**Re: Initial Submission Review – Crippen Property – Zoning Map Amendment and Master Plan**

Application Number: **DA-1435-02**

Case Numbers: **2000-2027-02; 2023-7007-00**

# Initial Submission Review

Examples of Building Designs

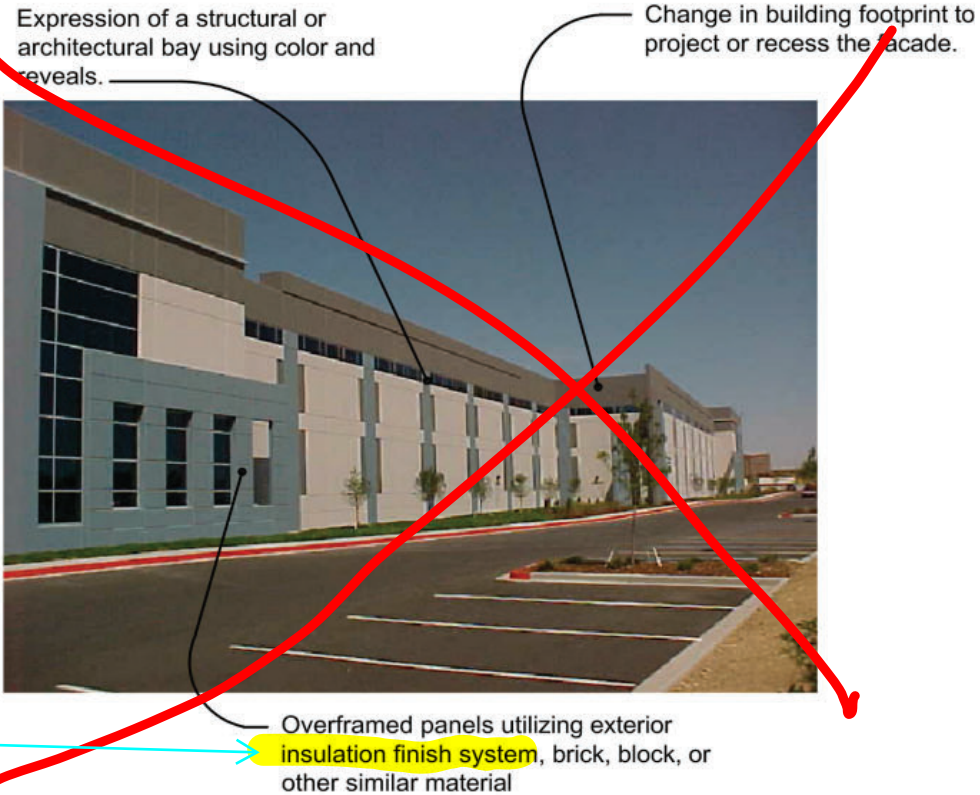
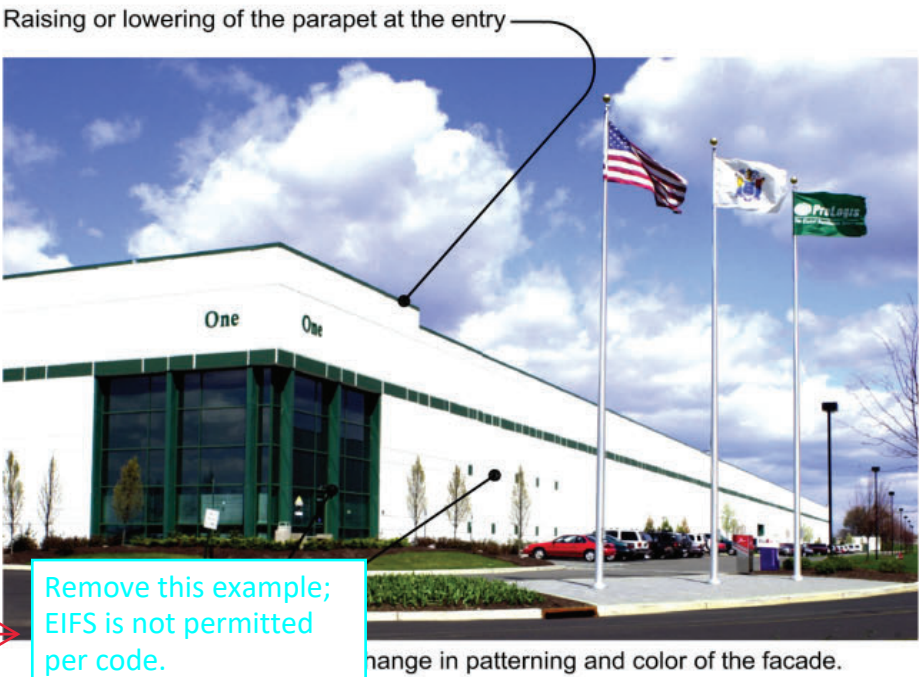
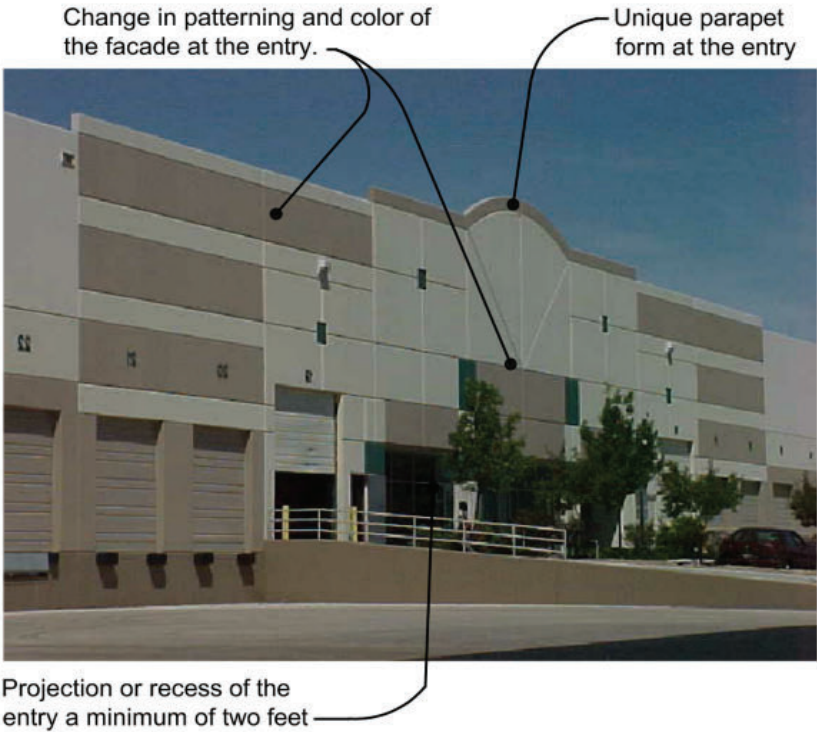
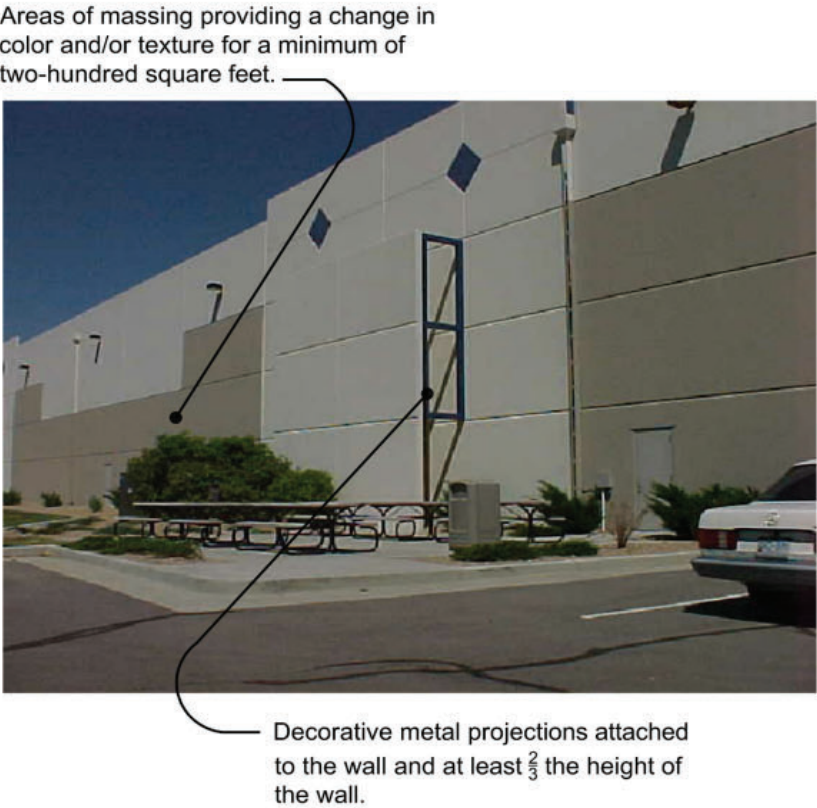
Remove this example;  
EIFS is not permitted  
per code.

REPOSE: UNDERSTOOD.  
EXAMPLE REMOVED.

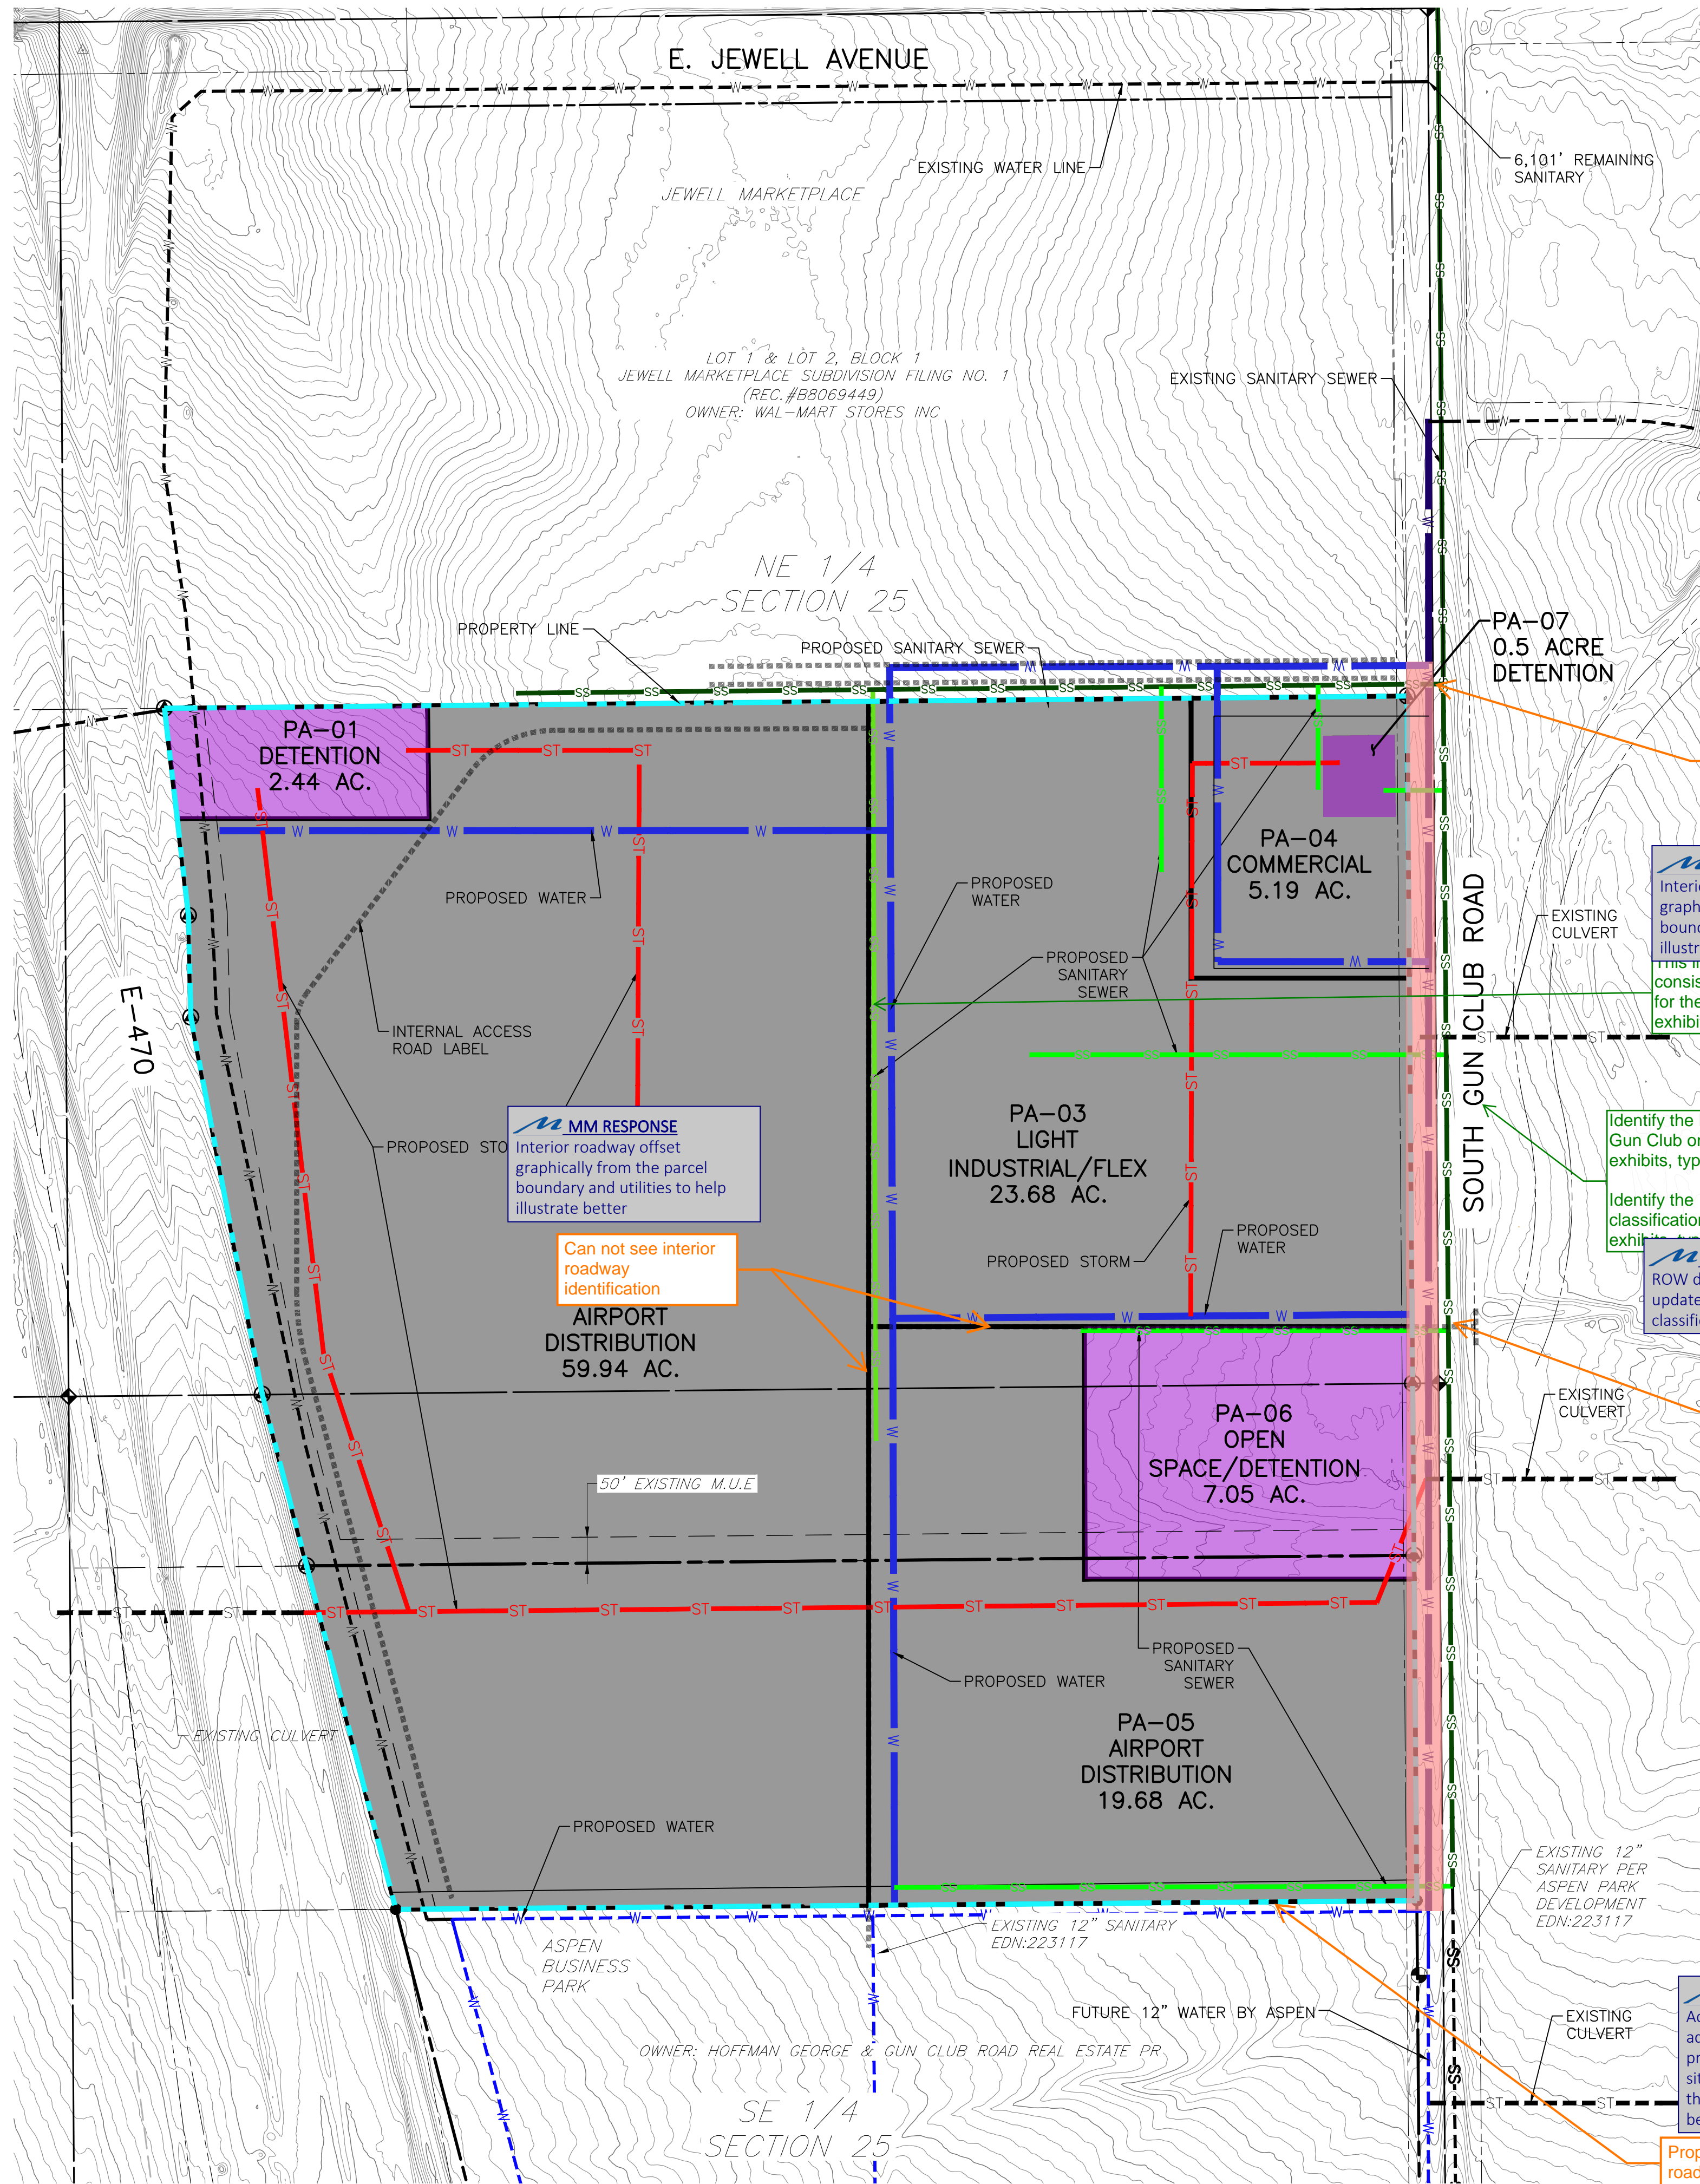
Include narrative describing the open space/park-like use and amenities that will be open to the public and also serve the employees in this area.

additional narrative discussing that the plan may include gathering spaces with hardscape and enhanced landscape like amenities will be at site plan dependent on final user

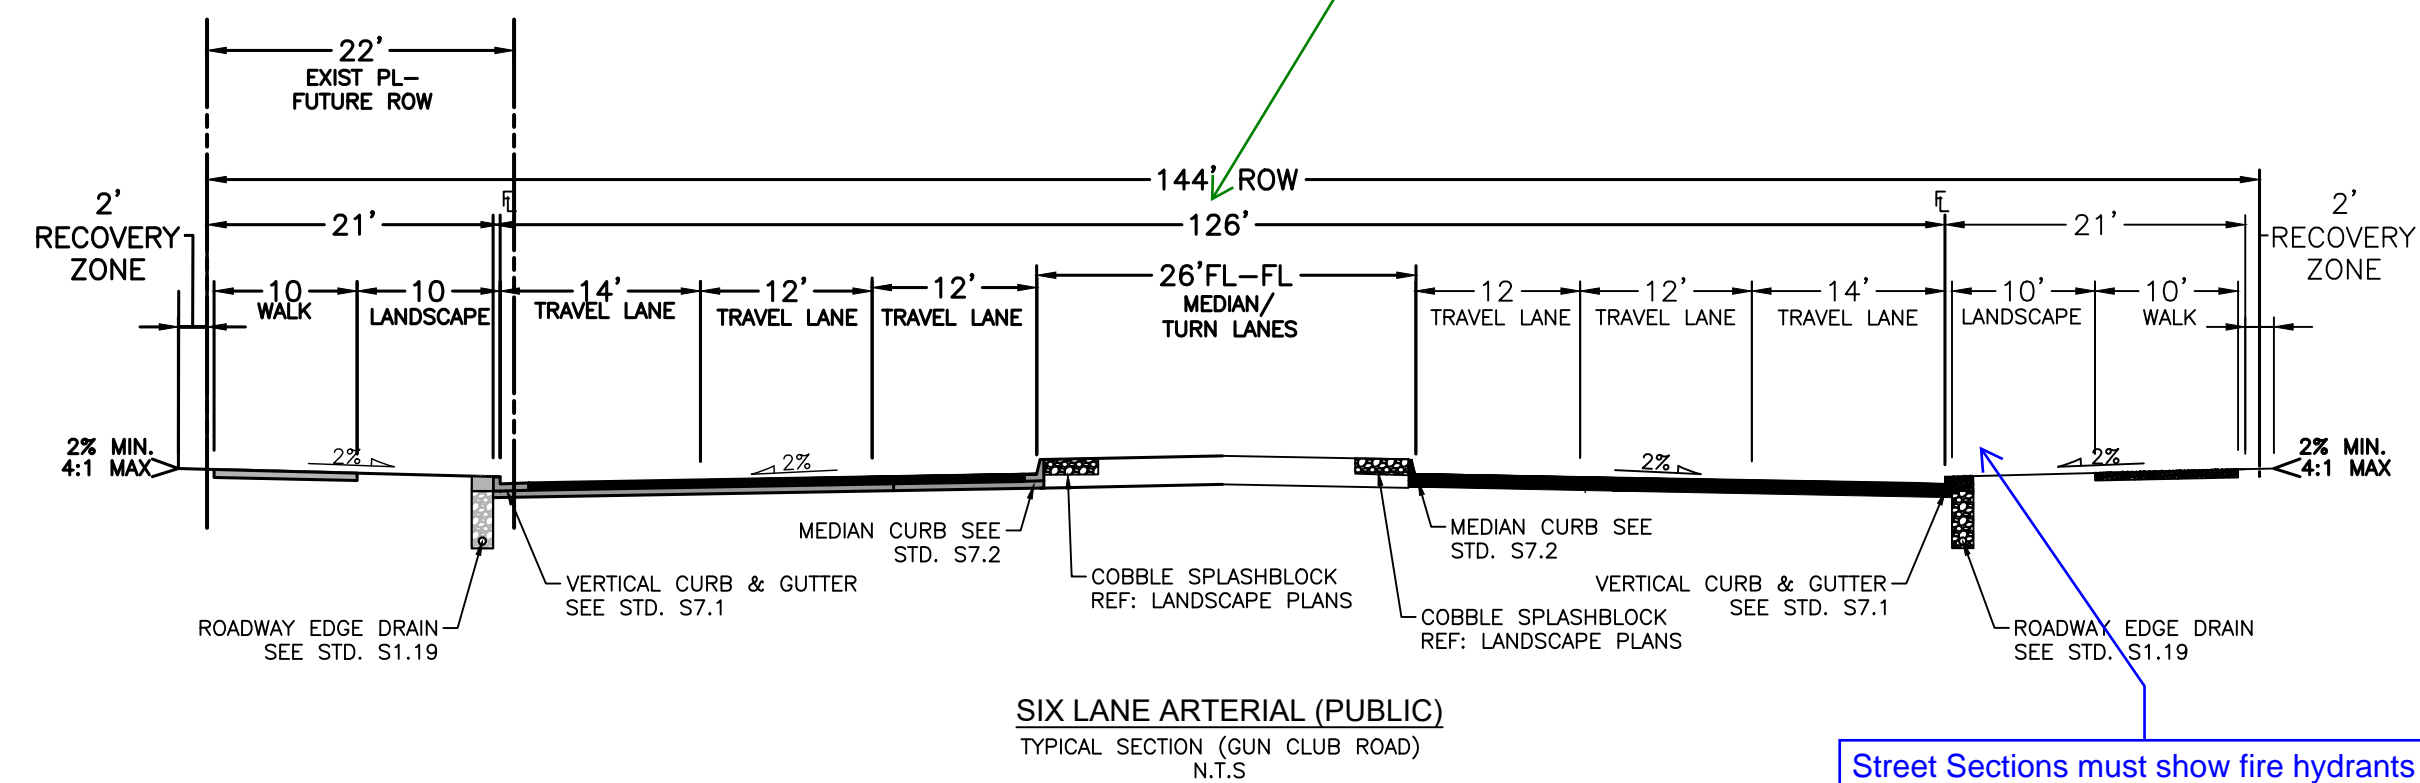
Call out access control

**MM RESPONSE**  
Access symbol added

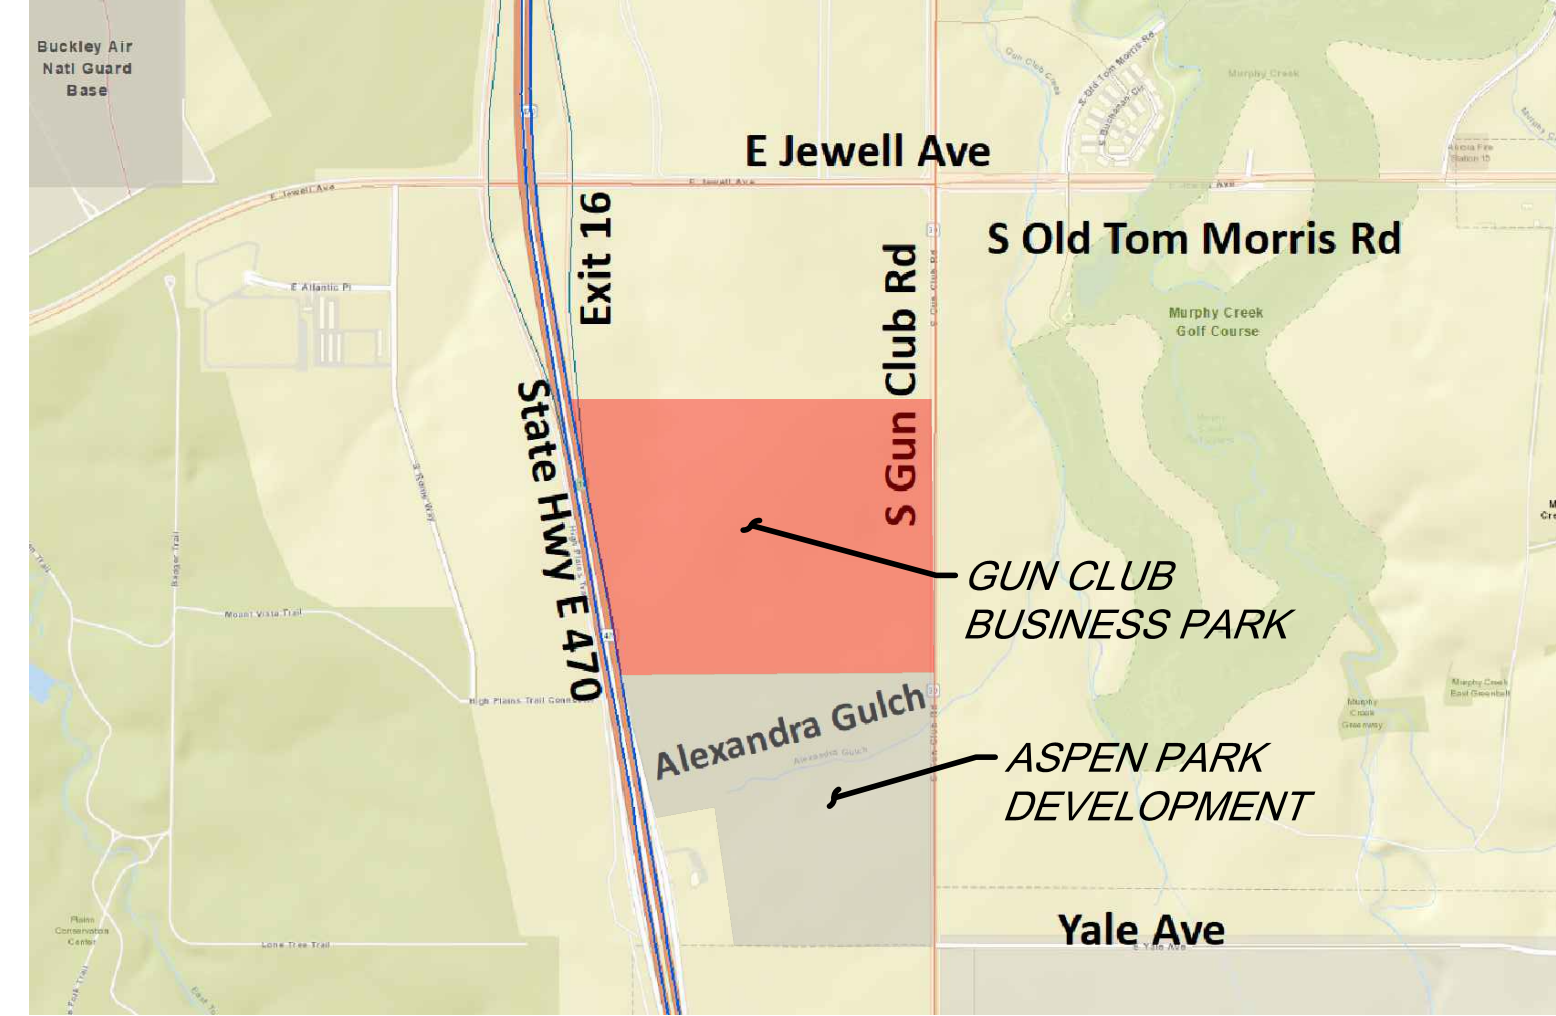
Street Sections must show fire hydrants in the landscape areas between 3'6" minimum and 8' maximum from the back of face of curb. TYPICAL

**MM RESPONSE**  
Section updated to show Fire Hydrant improvements proposed with this project and which ones are future

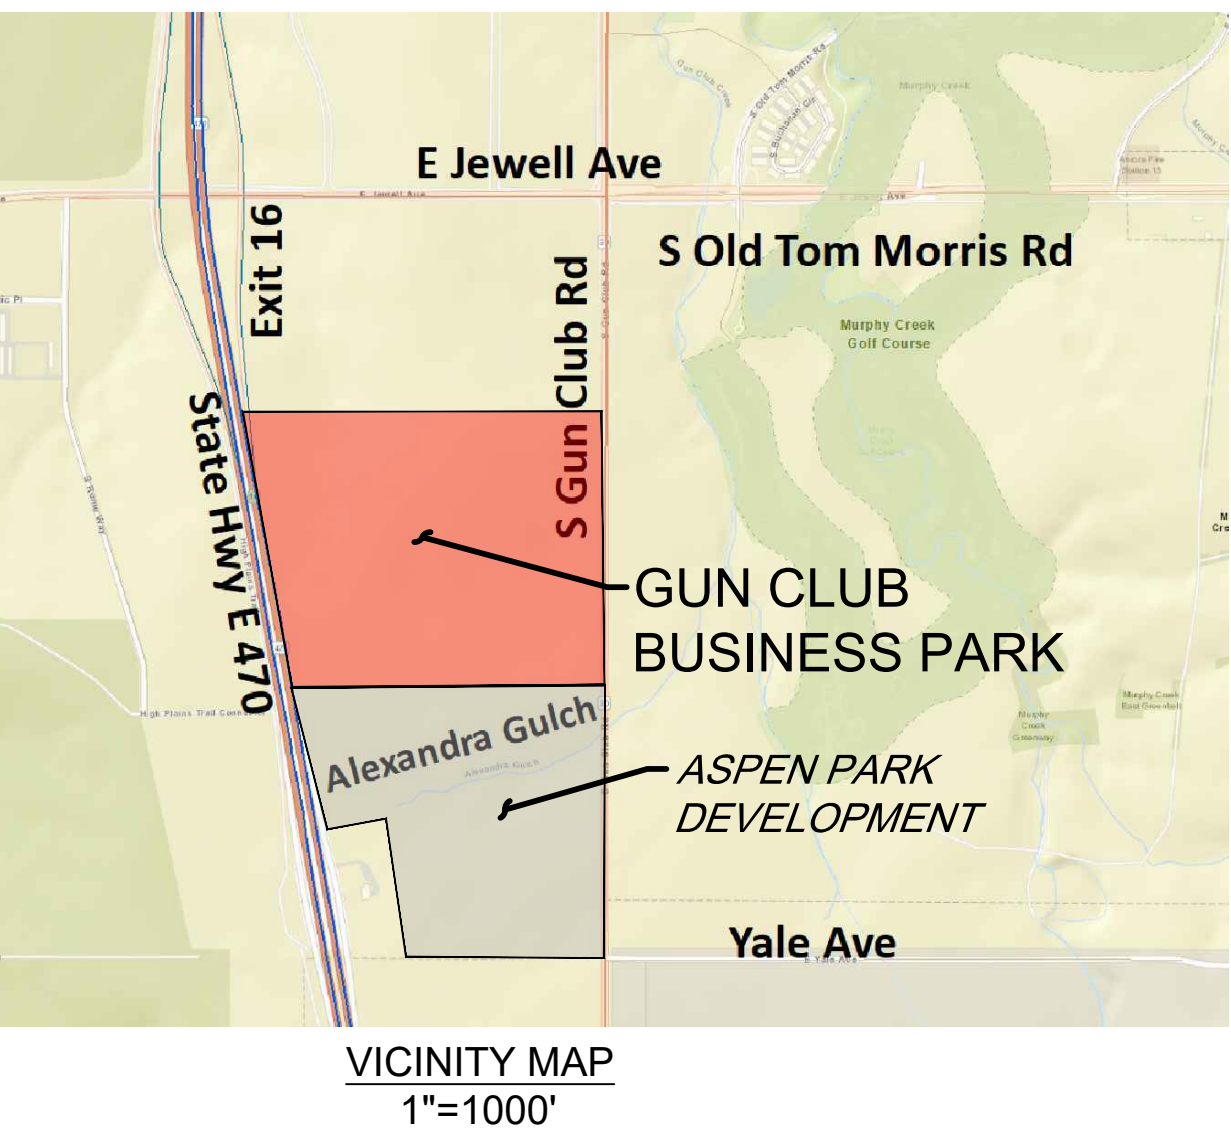
Remove fire from the sanitary signature block.

FIRE HAS BEEN REMOVED FROM SANITARY SIGNATURE BLOCK
